# PCC recommendations on the IRP2023: March 2024

This submission reflects the technical analyses, and commissioner and stakeholder inputs that underpin the PCC's critical appraisal of the DMRE's Draft IRP 2023. The IRP is a key document pertaining to South Africa's national long-term electricity planning.

Figure 21: Carbon Emissions Analysis for both Horizons

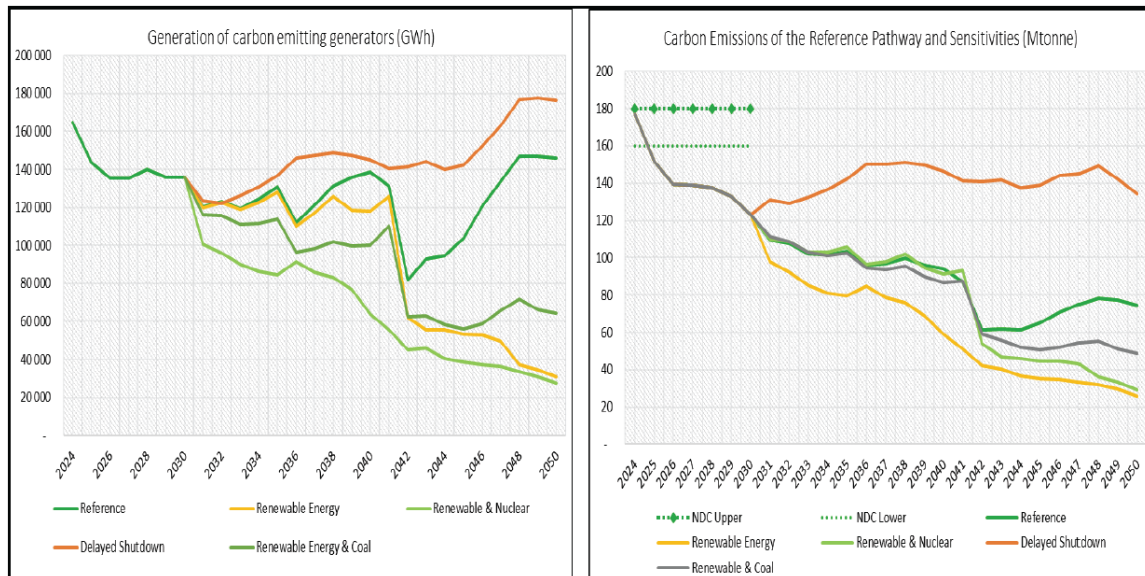
- The emissions starting point at the end of 2023 is 180 MtonneCO<sub>2</sub>e, which is significantly below the emissions of 200 MtonneCO<sub>2</sub>e reported for the end of 2022 by Eskom in their annual reports. It is possible that this discrepancy is due to extreme levels of loadshedding in 2023, but the DMRE should provide its emissions reduction calculations in this regard.

- The reduction in CO<sub>2</sub>e emissions from 2024 to 2030 is disproportionate to the reduction in energy output. Figure 21 shows a reduction in roughly 23 000 GWh with corresponding reduction of 40 000 MtonneCO<sub>2</sub>e. This does not align with emissions factor of 1.013 tonneCO<sub>2</sub>e/MWh published by the DFFE, and requires further exploration by the DMRE.

- The range of CO<sub>2</sub>e emissions limits for the Horizon 1 period from 2024 to 2030 is indicated in Figure 21 as 160 to 180 MtonneCO<sub>2</sub>e. This is different to that calculated by the PCC of 140 to 190 MtonneCO<sub>2</sub>e (based on an 80% share of reductions). It is important to align on the contribution by the power sector towards meeting the NDC (Nationally Determined Contribution) targets for reduction of CO<sub>2</sub>e, and the PCC and the DMRE need to resolve this issue.
